**RE: City of Lake City, SC
Lake Swamp WWTP Upgrade
CEI Project No. 100392.02**

ADDENDUM NO. 3 – June 10, 2021

EXISTING BLOWER BUILDING
 DEMOLITION PLAN
 CITY OF LAKE CITY
 LAKE SWAMP WWTP UPGRADE

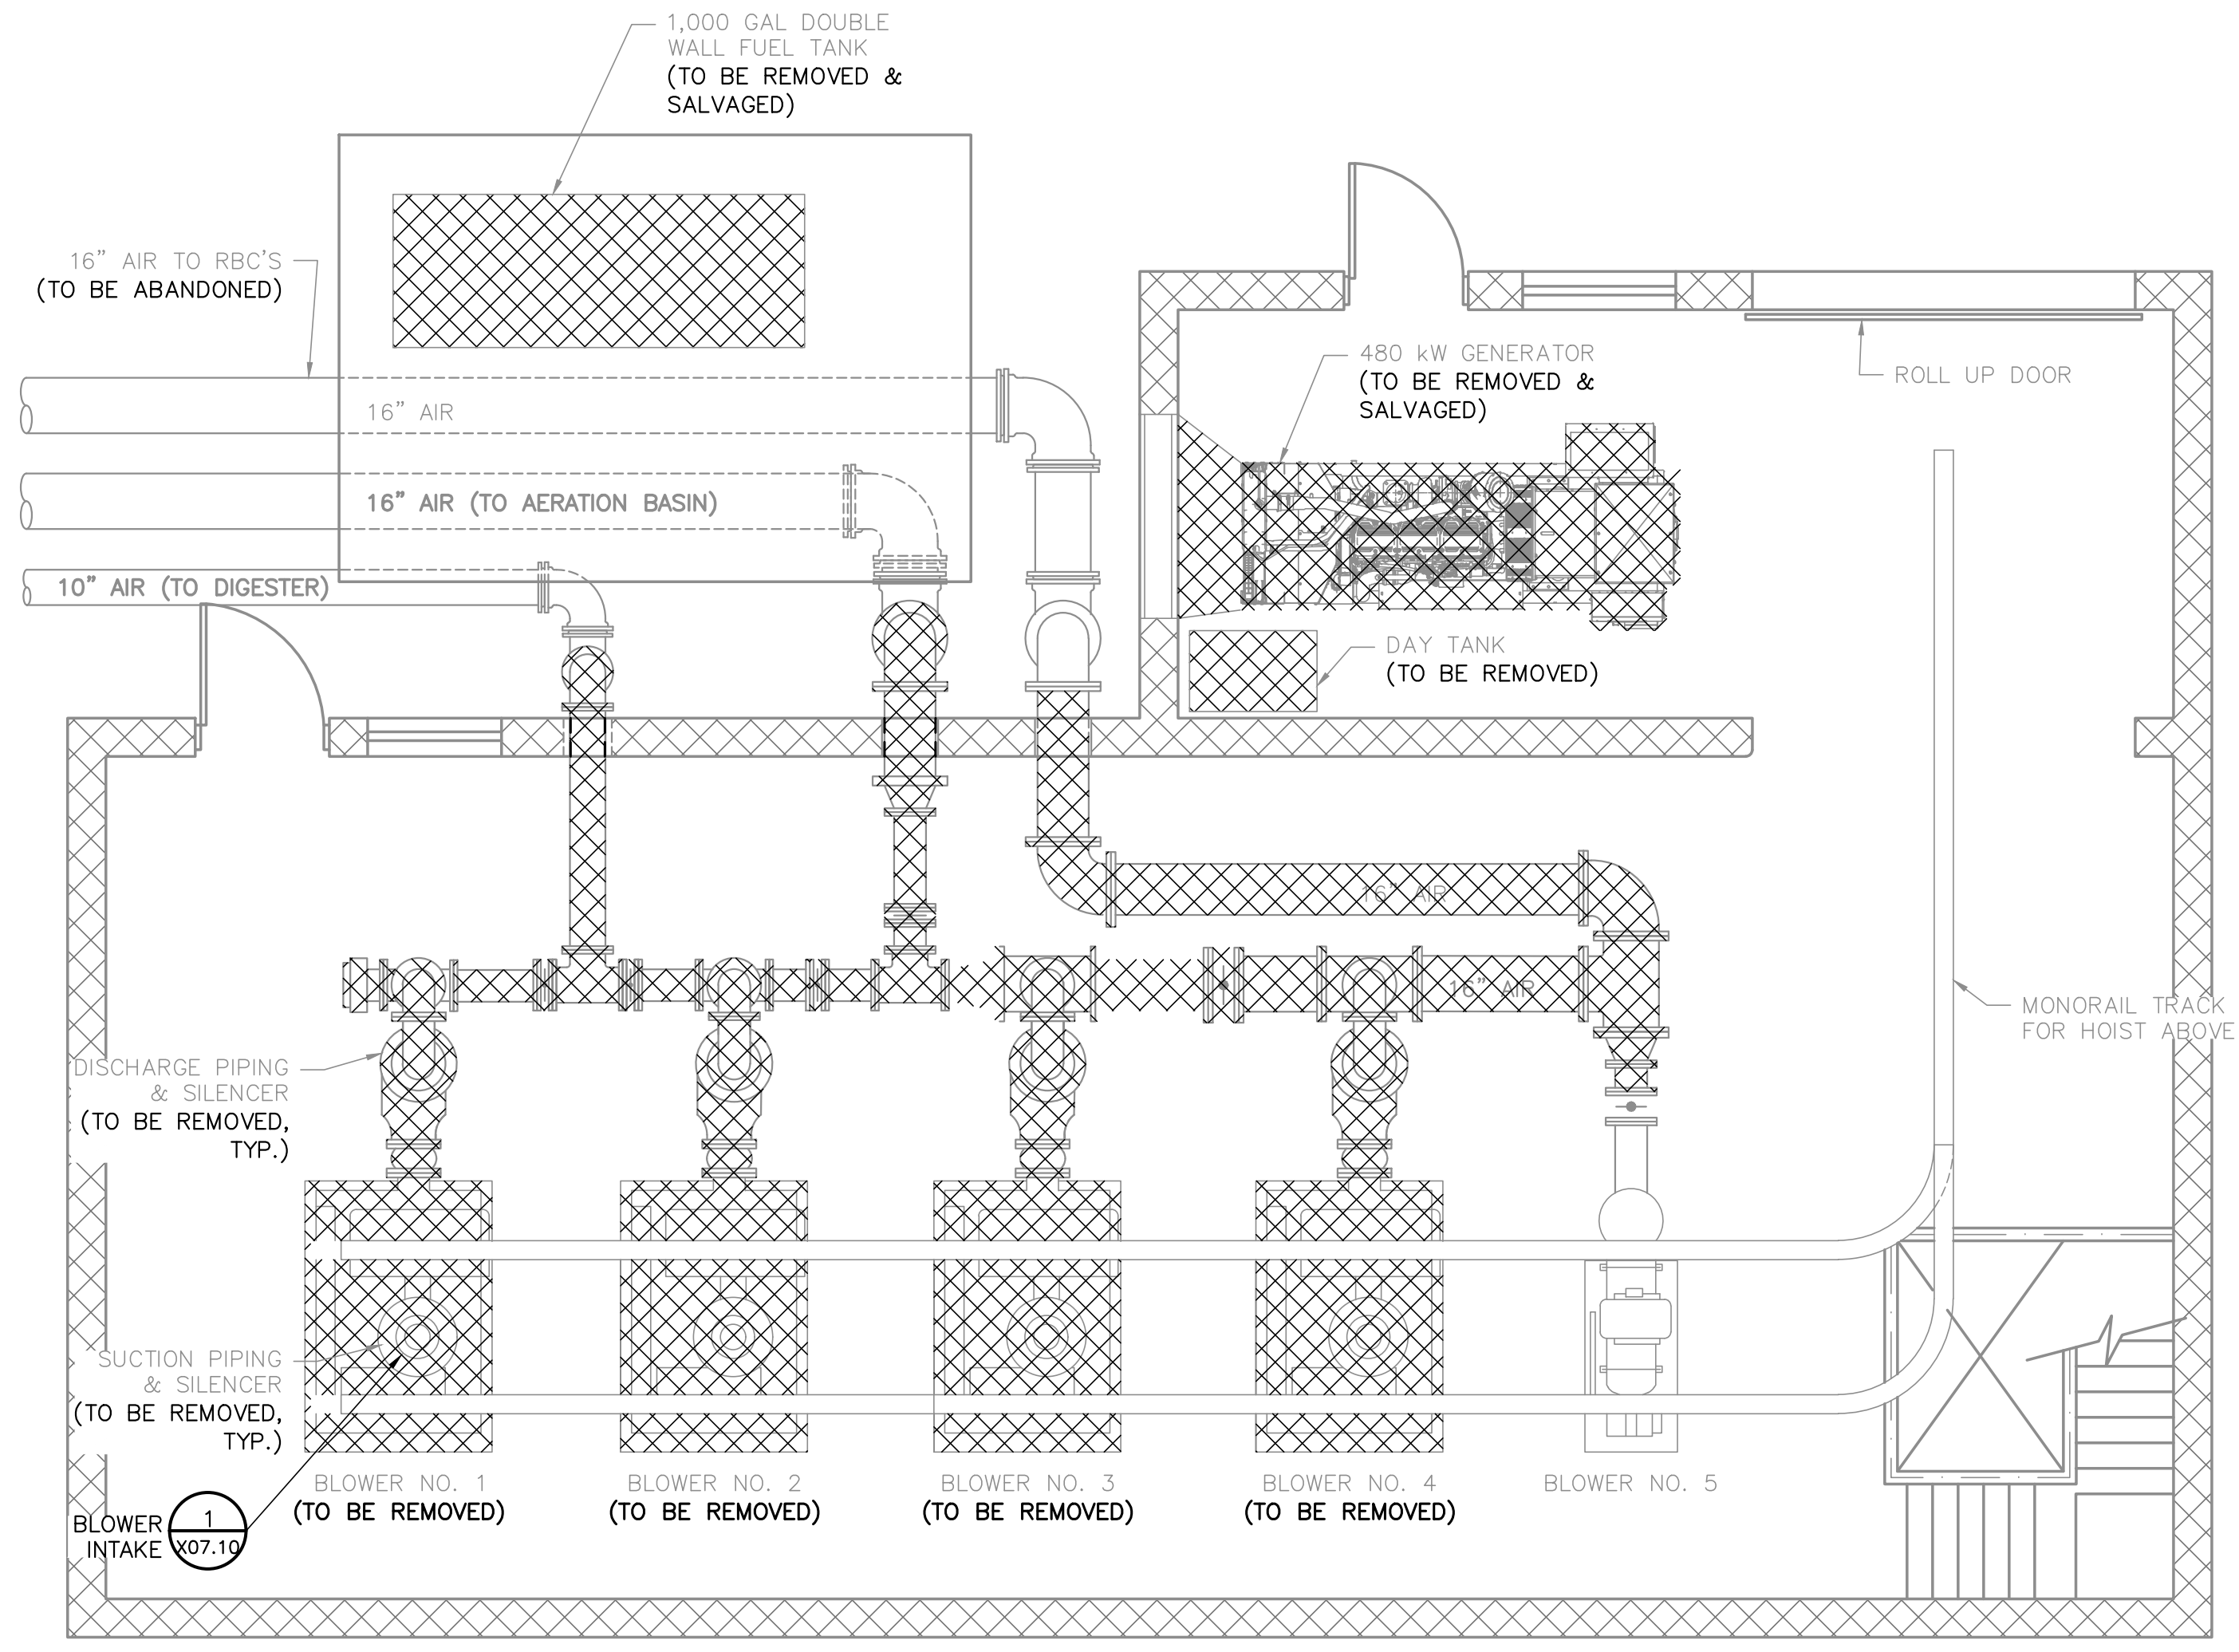
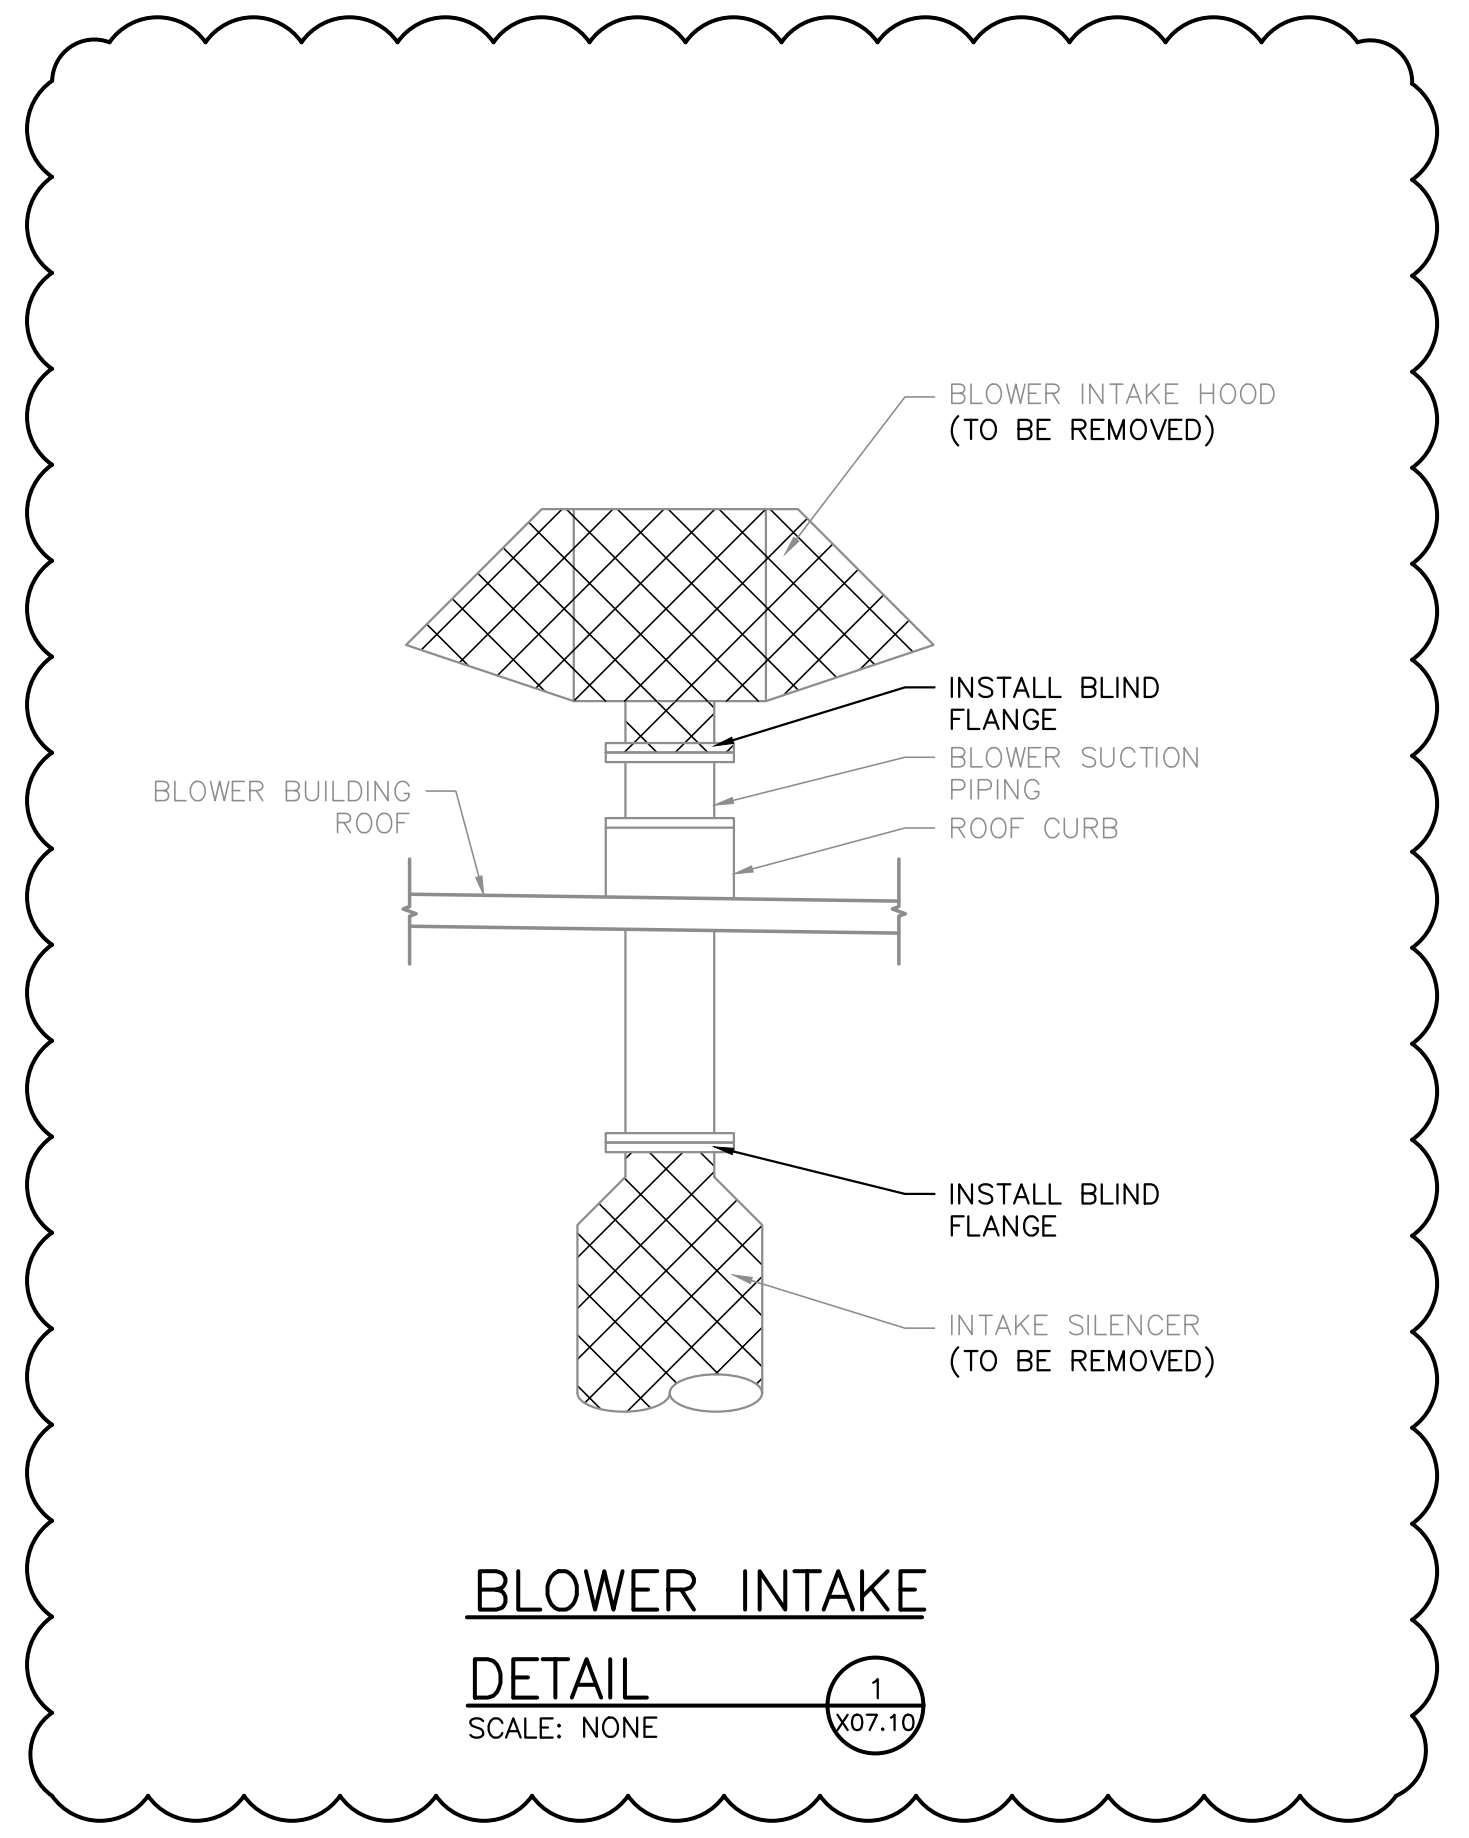
- c. Delete the 8"DRN shown on the Top Plan and Section A. There is no drain line for this basin.
- 5. Sheet X07.10:
 - a. Replace in its entirety with the attached.
